Change Order, Construction Manager as Adviser Edition

PROJECT: <i>(name and address)</i> Central Hardin High School Addn/Renov Cecilia, KY	CONTRACT INFORMATION: Contract For: BP 099-10 Painting & Joint Sealants Date: July 14, 2021	CHANGE ORDER INFORMATION: Change Order Number: 106 Date: March 13, 2024
OWNER: <i>(name and address)</i> Hardin County Board of Education 65 W A Jenkins Road Elizabethtown, KY 42701	ARCHITECT: <i>(name and address)</i> JRA Architects 3225 Summit Square Place, Suite 200 Lexington, KY 40509	CONSTRUCTION MANAGER: <i>(name and address)</i> Alliance Corporation 116 E. College Street Glasgow, KY 42141
CONTRACTOR: <i>(name and address)</i> Bastin Painting 319 N. 3rd Street Danville, KY 40422

Proposal Request

Architect's Project Number: 2019111
Proposal Request Number: 052

FIRE SAFETY CLOSURES			PR 58 1
CENTRAL HARDIN HIGH SCHOOL HARDIN COUNTY SCHOOLS			
PROJECT: 2019111	DATE: 1-15-24	DRAWN BY:	DRAWING

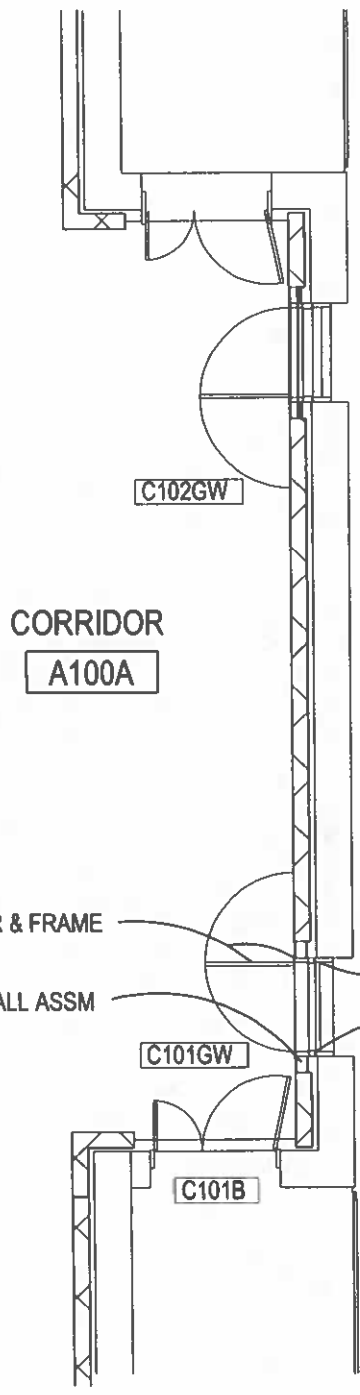
At the wall between the existing gym and the addition, provide a 3'-8" by 7'-0" HM door with 4-sided HM frame at each window location as well as new door hardware. Refer to attached drawing, PR 58-1, dated 1-15-24, and attached Hardware Set E06. Install frame in 2-hour fire rated shaftwall system using 4" studs. Install the fire rated joint system between the shaftwall and the CMU wall for the window.

Connect the magnetic hold open closers for both doors to the fire alarm system. Connect to the nearest available fire alarm circuit. Run the circuits above the lobby ceiling through the CMU wall, down the space between walls and into the head of the door frames to the closers. Install system smoke detectors located at bottom of the roof deck on the gym side of each of the 2 windows in the gym.

1. ALIGN DOOR FRAME WITH EXIST. WINDOW.
2. PROVIDE FLUSH, 3'-8" X 7'-0", 90 MIN. RATED HM DOORS.
3. PROVIDE 4 SIDED, 6-1/4" DEEP, HM FRAMES.
4. PROVIDE HARDWARE PER THE ATTACHED.
5. INSTALL FRAMES IN 2 HR RATED SHAFTWALL W/ 4" FRAMING. ALIGN FACE OF WALLBOARD W/ BACK OF RADI ON BULLNOSE BLOCK.
